Date: 7-6-79 Change Reference: M35698 REV.  
Product: 7L18 EFF SN B020534 REV. 8-9-79 Manual Part No.: 061-1469-02

#### ELECTRICAL PARTS LIST AND SCHEMATIC CHANGE

Product: 7L18 SPECTRUM ANALYZER INTERIM SERVICE

DIAGRAM  VIDEO AMPLIFIER - Partial

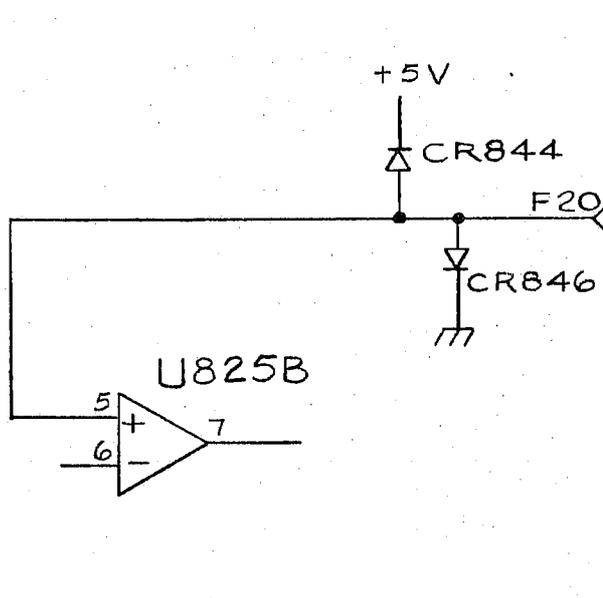
ELECTRICAL PARTS LIST AND SCHEMATIC CHANGES

ADD:

CR844 152-0141-02 SEMICOND DEVICE:SILICON,30V,150MA

CR846 152-0141-02 SEMICOND DEVICE:SILICON,30V,150MA
